Kevin Bilash  
US Environmental Protection Agency Region III  
1600 John F. Kennedy Boulevard  
Philadelphia, PA 19103

February 3, 2023  
File No. 4862.10

Re: Revised Responses to USEPA's October 13, 2022 and December 15, 2022 Comments  
Concerning the September 2022 IM Monthly Progress Report for AOI 7 in MHT

## AOI 7 Cross Section A-A'

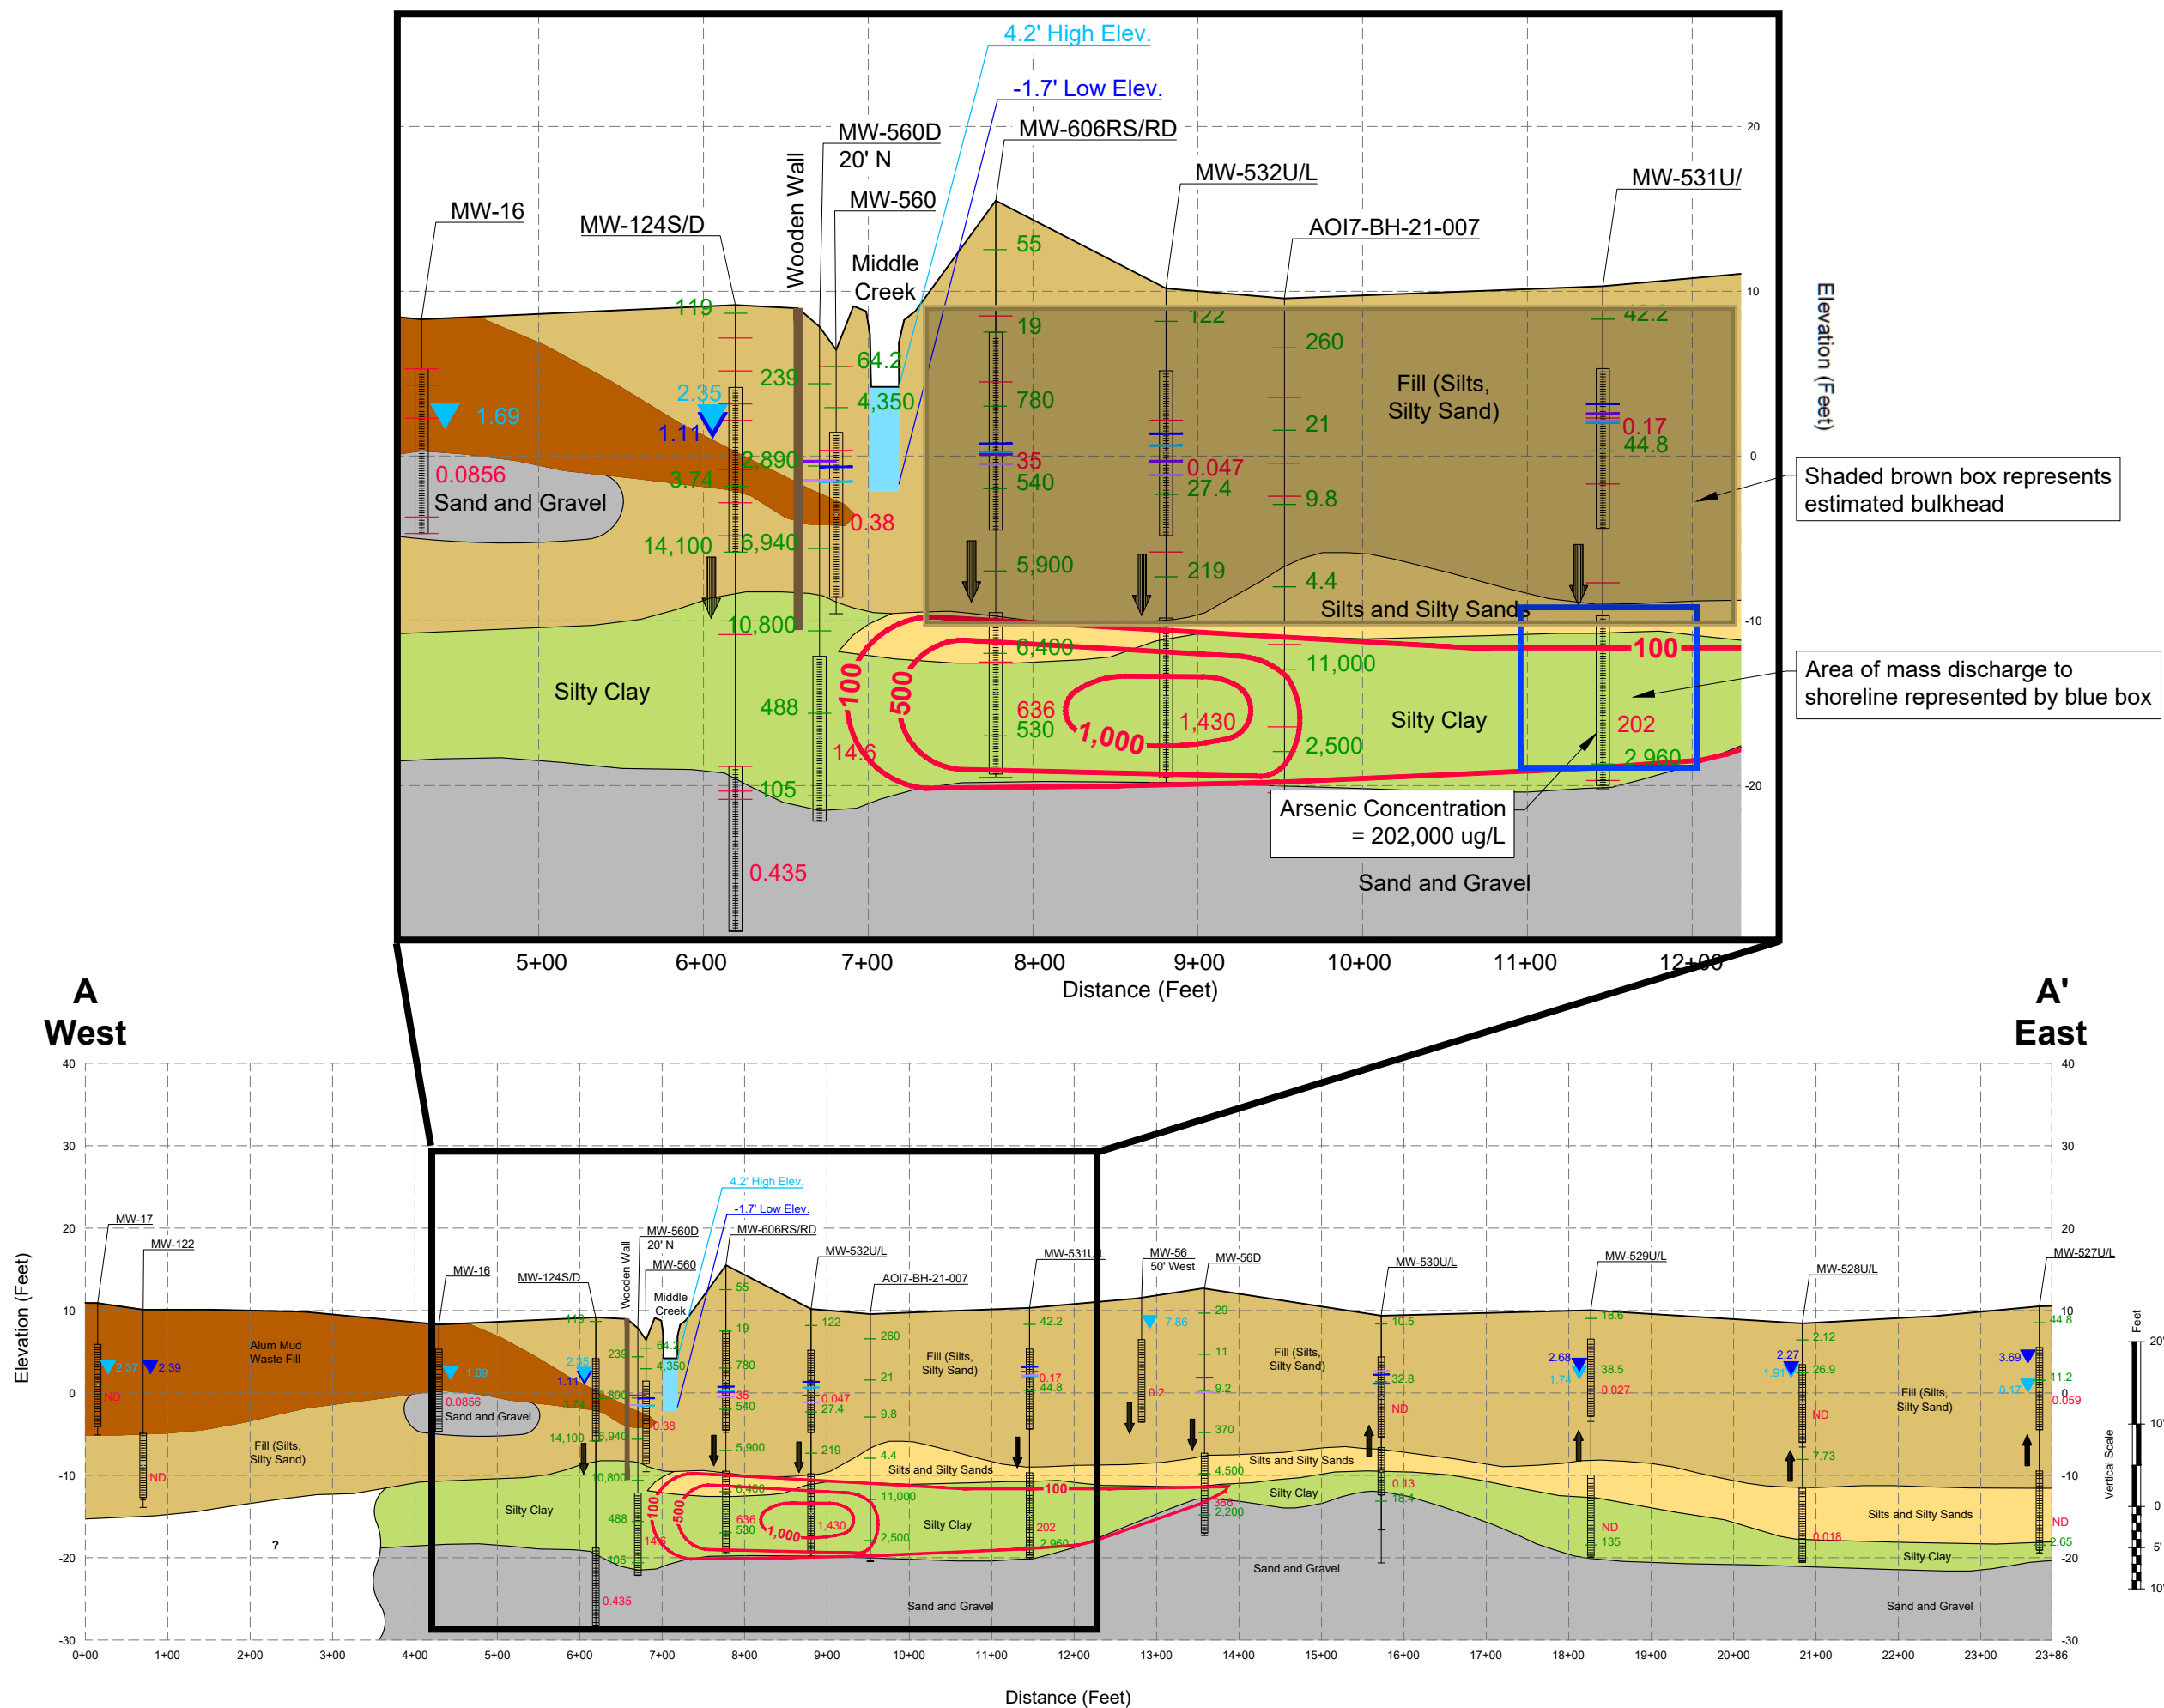
**Comment 2:** *Discussion 2.2. A second discharge volume should be calculated for the riverfront area near MW-531L and MW-531U. The request is being made because: 1) collectively the dissolved arsenic plume is observed extending beyond the bulkhead in this area and sediment PRG exceedances are located immediately downgradient; and 2) the sediment, represented by samples SED-13 and SED-16 is not currently planned to be addressed.*

**Response to Comment 2:** Attachment G includes the calculations for arsenic mass discharge from the MW-531U/L area to the closest sediment sample above the sediment PRG (SED-13). Figure 2 in Attachment G shows the cross-sectional area of mass discharge for this calculation and Figure 3 in Attachment G shows the width of the plume/area of discharge. Note that the mass discharge was calculated using a concentration of 202,000 ug/L arsenic (which is conservative because this is the highest concentration found at MW-531L) and the area used for the mass discharge considered the sandy silt layer as an area of mass discharge in addition to the clay layer beneath as a conservative estimate. This mass discharge was used to theoretically calculate the time for porewater discharge in the MW-531U/L area to potentially accumulate in sediment and reach the sediment concentration found at SED-13 (198 mg/kg), if this reaction could occur at the site, which is not predicted to be possible based on the Geochemist's Workbench modeling in Attachment E. Assuming, however, that this reaction could occur, the arsenic mass discharge from the MW-531U/L area would take over 1,300 years to accumulate in sediment to the SED-13 arsenic sediment concentration of 198 mg/kg, which further shows that this process is not occurring since
